SUBJECT: R.E. Ginna Nuclear Power Plant
Docket No. 50-244

Reply to Request for Additional Information RE: Revisions to Loss-of-Power Diesel Generator Start Instrumentation Limiting Safety System Settings and Diesel Generator Load Test Value

Response to Request for Additional Information Regarding Revisions to Loss-of-Power Diesel Generator Start Instrumentation Limiting Safety System Settings and Diesel Generator Load Test Value

Figure 21, DGA_FU2, DG voltage (% 480V) profile

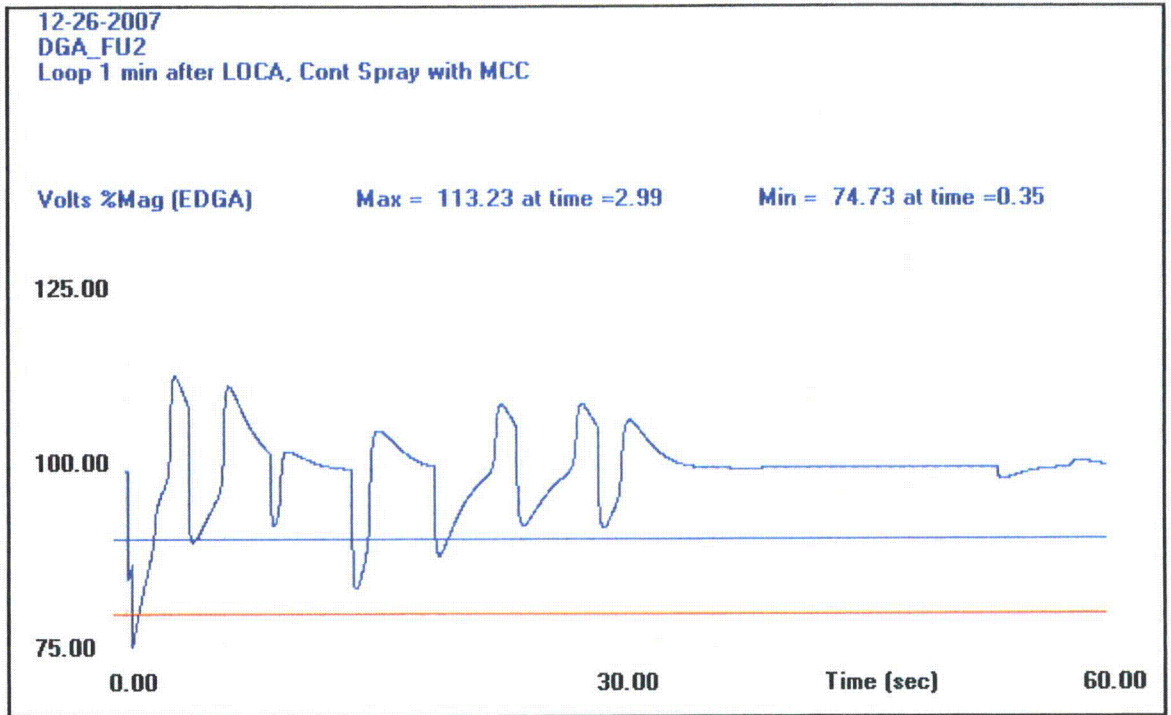
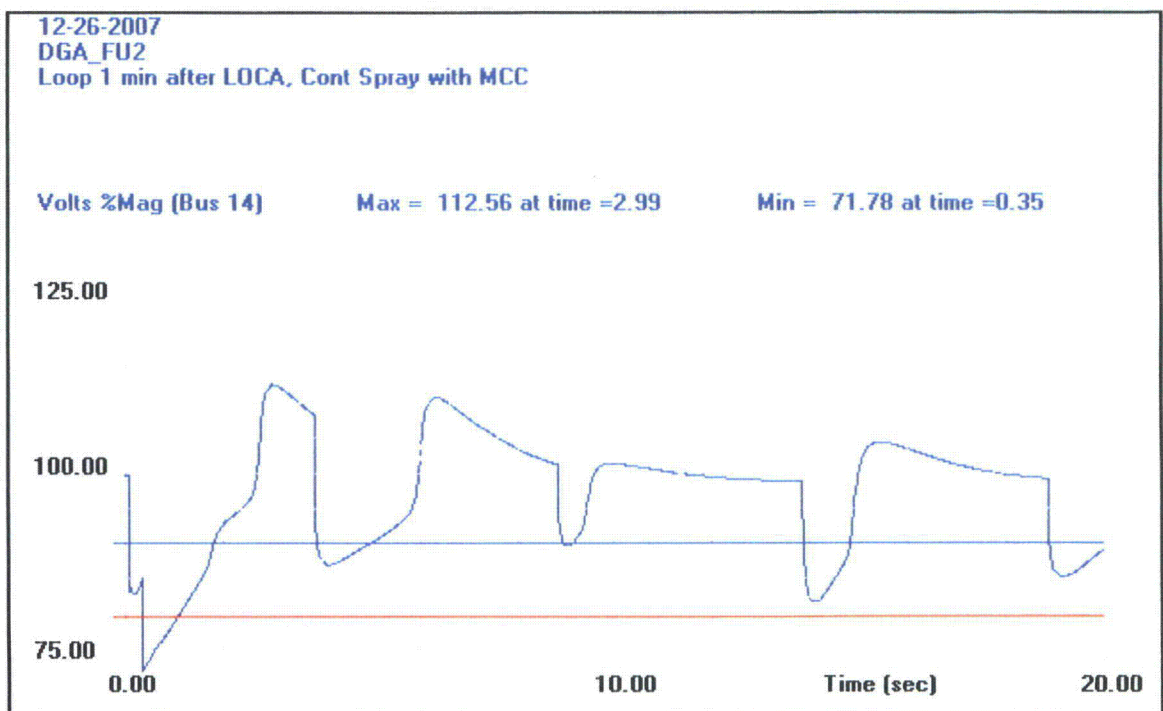
The NRC staff could not find the requisite response (voltage and frequency simulation) in Attachment 6 of the licensee's submittal. Please provide analysis for the worst case voltage and frequency transients of the diesel generator, if a containment spray pump is started coincident with another large load, and compare the voltage and frequency variation limits to those recommended in Regulatory Guide 1.9.

Figure 21 demonstrate that there is a slight Regulatory Guide violation (V_{min} at EDG terminals = 74.73% and limit = 75%) however the loss of voltage relays will not inadvertently operate and all of the motors successfully accelerate. The loss of voltage relays on Bus 14 are picked up for 0.78 seconds (minimum operate time = 2.0 seconds) as is more clearly illustrated in the following figure.
